# United States Department of the Interior

October 19, 2012

**COMMENTS AND RECOMMENDATIONS--NOTICE OF APPLICATION  
ACCEPTED FOR FILING, SOLICITING MOTIONS TO INTERVENE AND  
PROTESTS, READY FOR ENVIRONMENTAL ANALYSIS, AND SOLICITING  
COMMENTS, RECOMMENDATIONS, PRELIMINARY TERMS AND  
CONDITIONS, AND PRELIMINARY FISHWAY PRESCRIPTIONS; LOUP RIVER  
HYDROELECTRIC PROJECT, PLATTE AND NANCE COUNTIES, NEBRASKA  
(FERC PROJECT NO. 1256-031)**

**Figure 1. Capture of USGS gaging data (provisional for recent period) for Platte River stage and discharge at North Bend, Nebraska, reflect the influence of the Loup River Hydroelectric Project.**

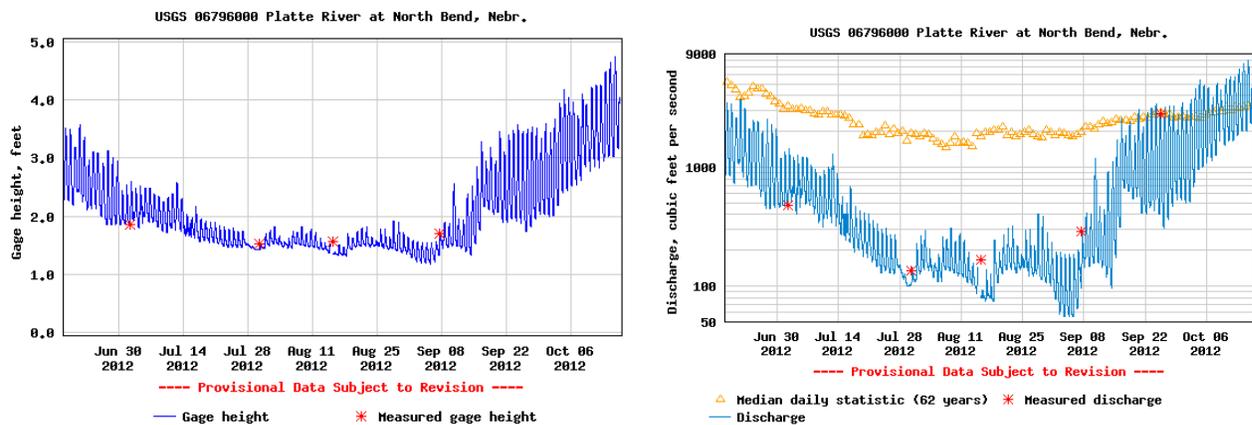
Fluctuations in the Platte River caused by the Project can be very large compared to Platte River base flows. The effect on Platte River hydrology attenuates downstream. However, at the USGS gaging station near North Bend, Nebraska, roughly 28 miles downstream of the Project tailrace, the Project discharges causes river stage to fluctuate as much as 1.5 feet over a 24-hour cycle (see recent period Figure 1). Platte River fluctuations are measurable at the USGS’ gage near Louisville, Nebraska (about 100 miles downstream), just above the Missouri River confluence. The magnitude of fluctuation varies seasonally and also varies year to year.

The USFWS recommends that a minimum base flow of 1,000 cfs be maintained from March 1 to August 31 at the Project tailrace return to the Platte River. This base flow would decrease impacts of Project hydrocycling on downstream river ecology. Compared to current operations, this base flow would reduce the magnitude of fluctuations (i.e., amplitude) of Project discharges, and in turn reduce Project impacts on longitudinal fragmentation of habitat for pallid sturgeon (*Scaphirhynchus albus*) and other fish species that use deep water habitats. Reduced amplitude of hydrocycling would also reduce adverse Project impacts to primary productivity that occur under current conditions.
